CITY OF FISHERS AGENDA

BOARD/COMMISSION: Nickel Plate Review Committee Meeting

Nickel Plate Review Committee Staff Report

DEPARTMENT CONTACT: Ross Hilleary (hillearyr@fishers.in.us)	CASE NUMBER: NPR-23-4
--	---------------------------------

Proposed Site Plan

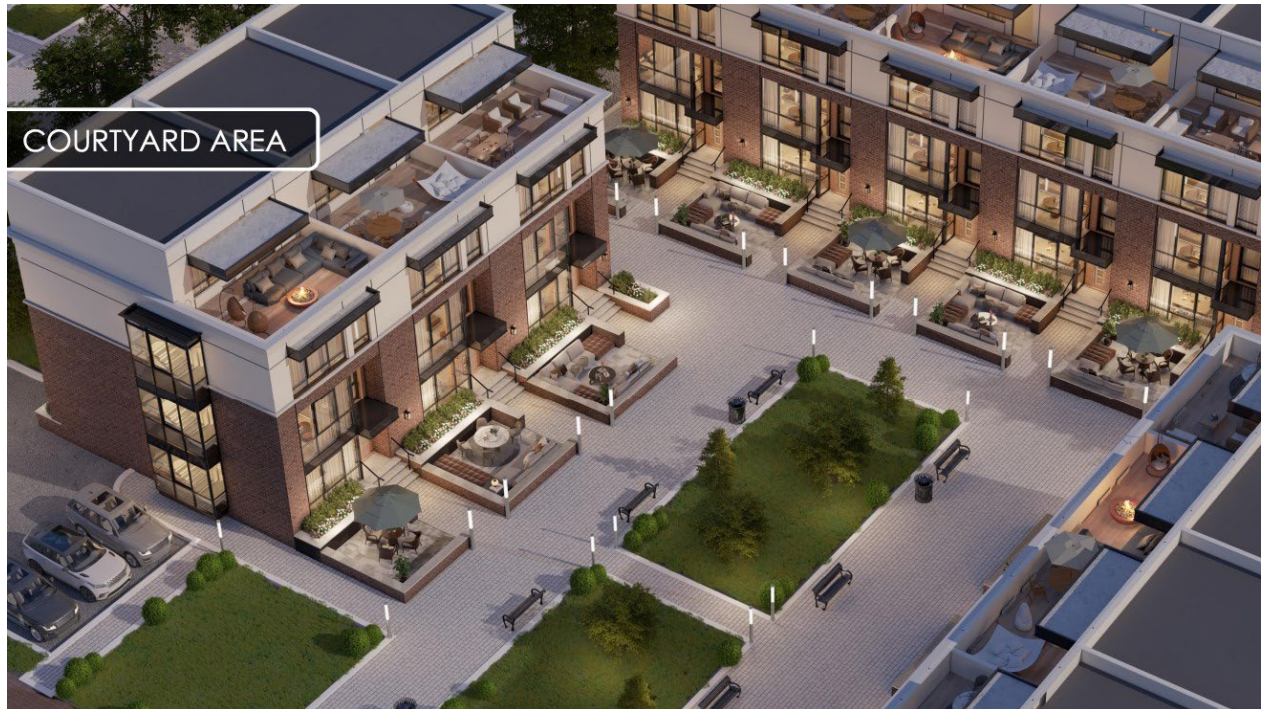
✓ Site access: The proposed vehicular access is approximately where E 121st and Circle Drive ROW is located now. Access will be continued to be discussed through the TAC Process. Pedestrian access is provided along Lantern Road with the standard NPD 15' pedestrian streetscape until the northern entrance where it will transition to a trail/sidewalk to the north, access will be provided along the Nickel plate Trail, including a signature staircase. Adjacent the apartments will be a public access trail point from Lantern Road to the Nickel Plate Trail.

✓ Parking and vehicle circulation: No new public right-of-way is being proposed. Parking is shared between garages and surface parking internal to the site.
